CITY OF BATON ROUGE
PARISH OF EAST BATON ROUGE
DEPARTMENT OF ENVIRONMENTAL SERVICES

November 14, 2024

ADDENDUM NO. 1

SUBJECT: **NORTH REGIONAL WASTEWATER CONSOLIDATION PROJECT**
CITY-PARISH PROJECT NO. 23-FM-MS-0038

SHEET NUMBER	C-4R
PARISH	EAST BATON ROUGE
CITY	BATON ROUGE
PROJECT	22-FM-MS-0023
DESIGNED	KC
CHECKED	DK
DATE	11/11/2024
NO.	1
REVISION DESCRIPTION	
BY	
DATE

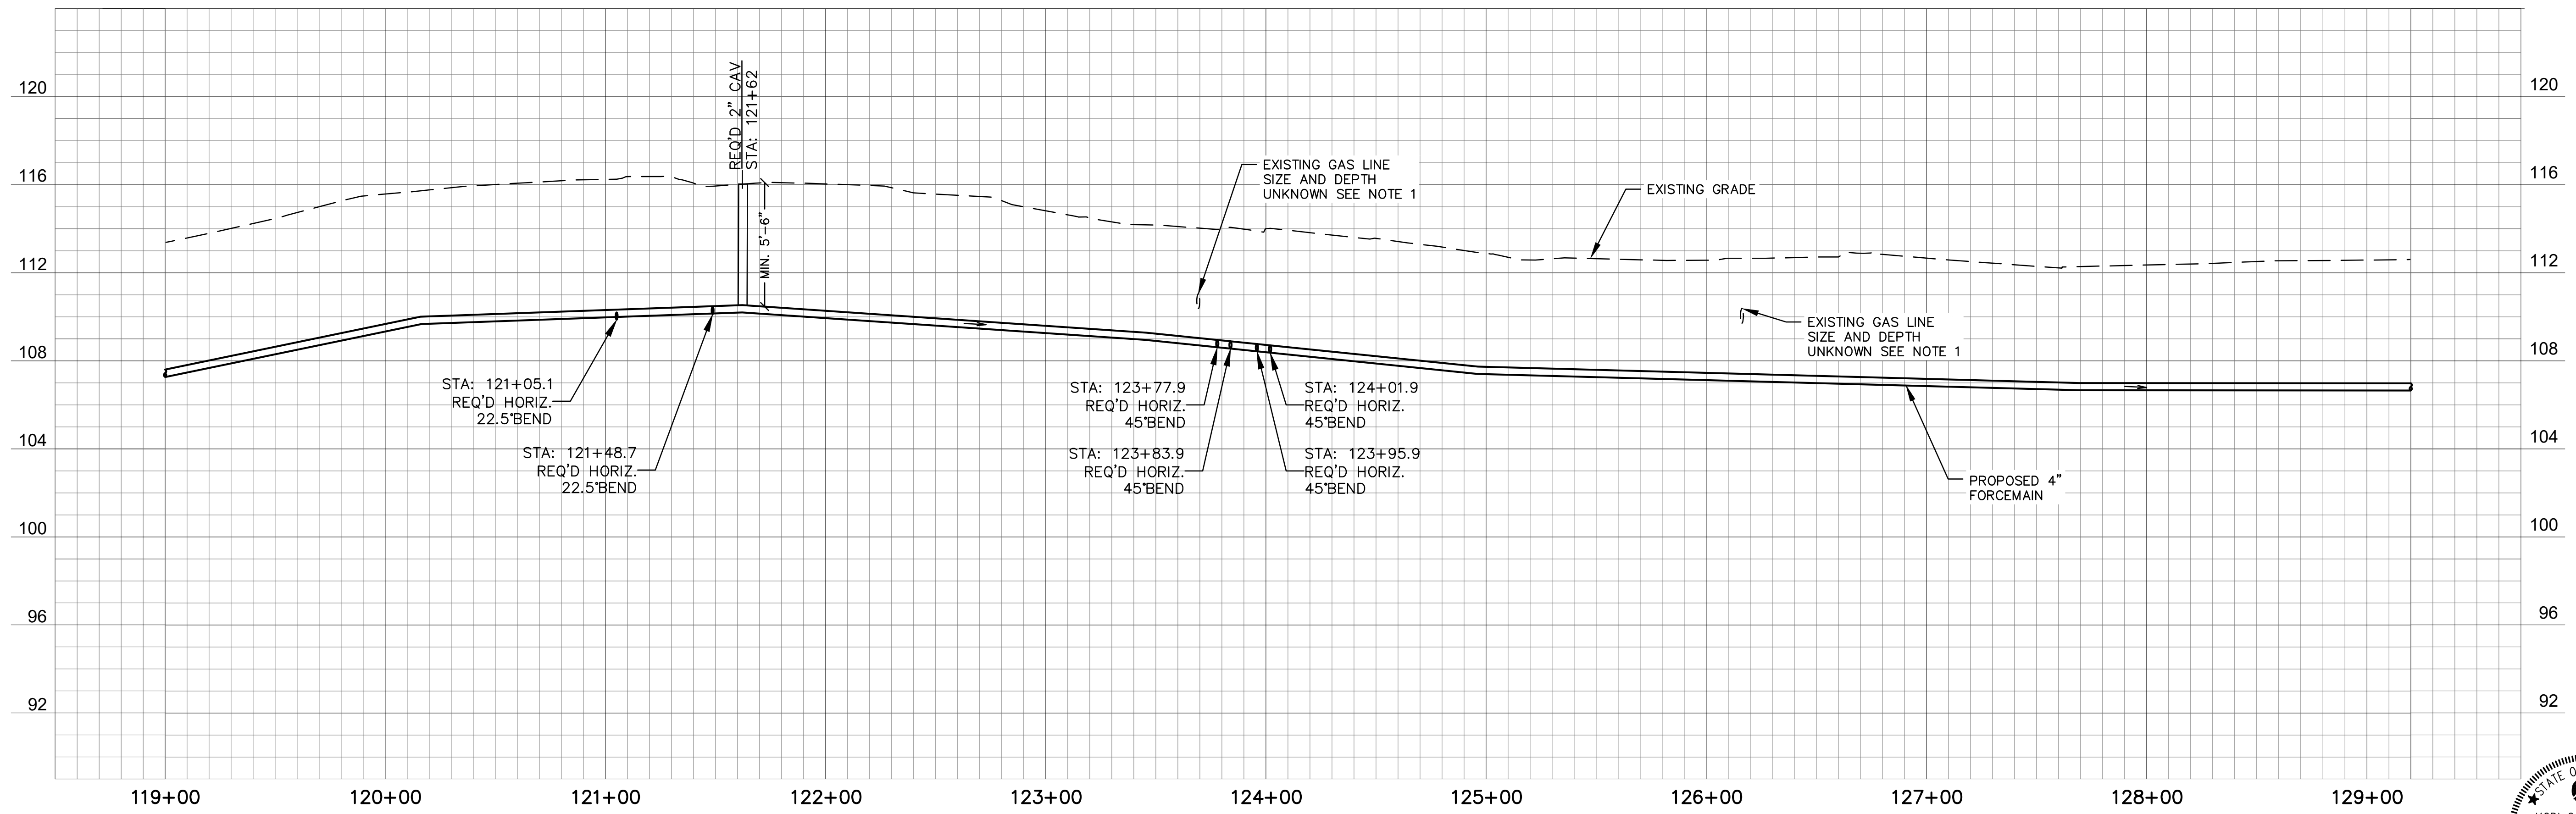
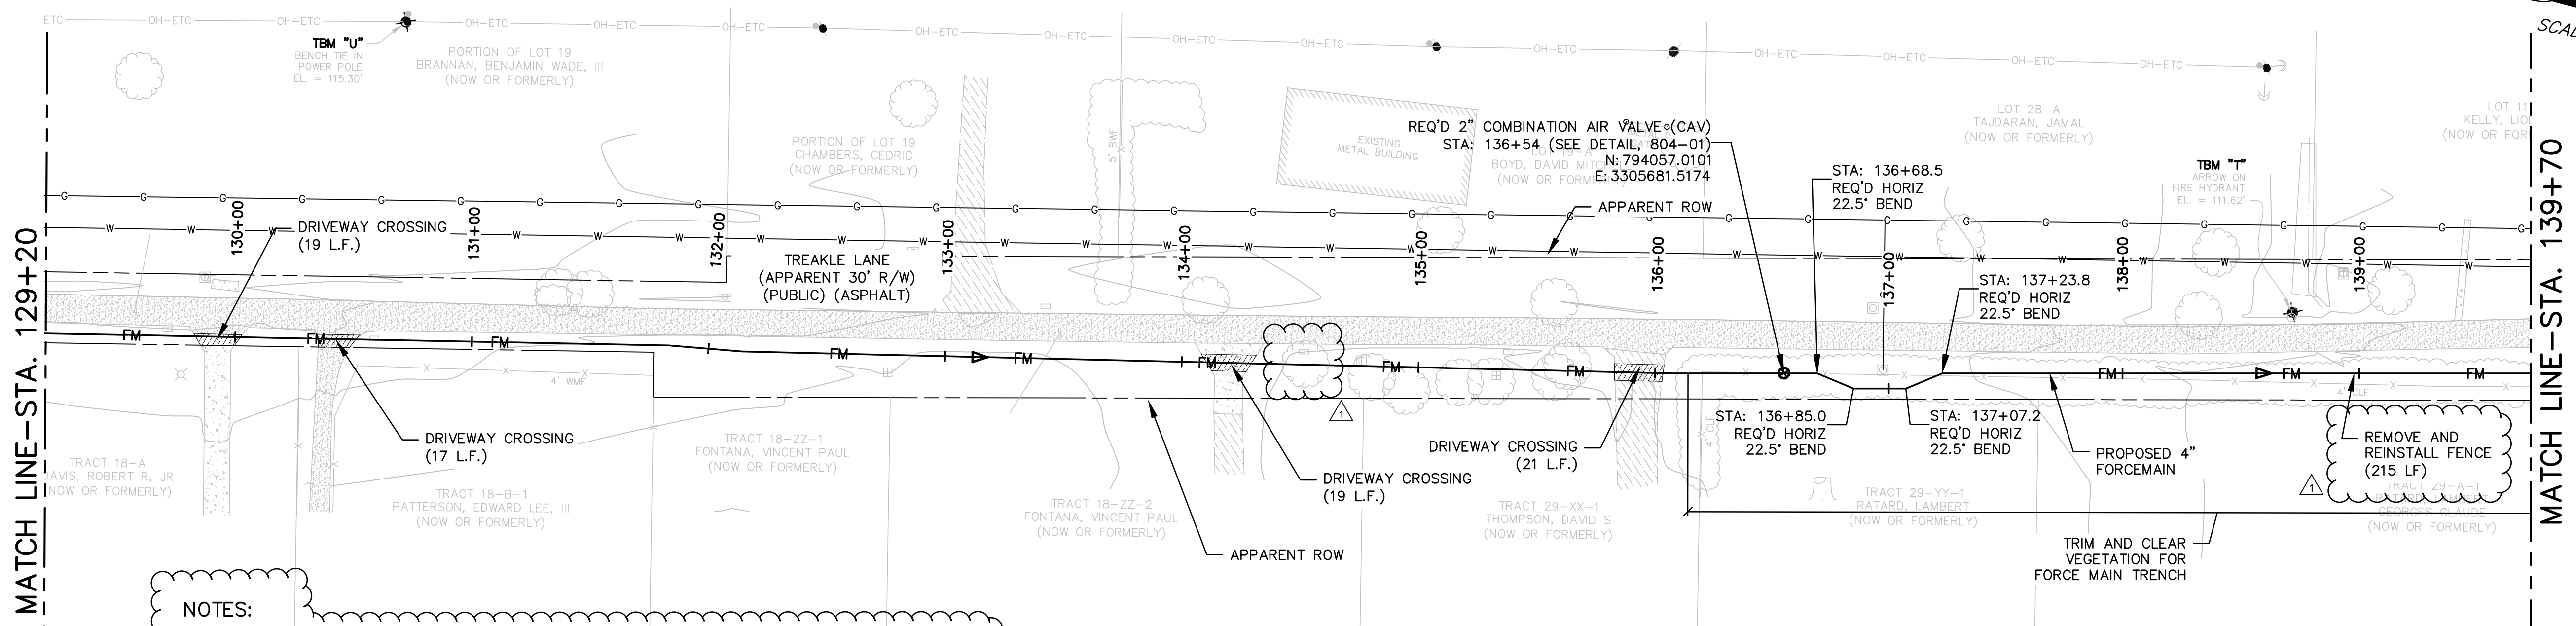
1. Sheet Number C-4:

Delete Note 3.

14. Sheet C-4 Note 3 Contractor shall avoid tree removal if required contractor can use trenchless installation, how will this be paid if trenchless installation is used.

Note 3 has been removed. See revised drawings attached to this addendum.
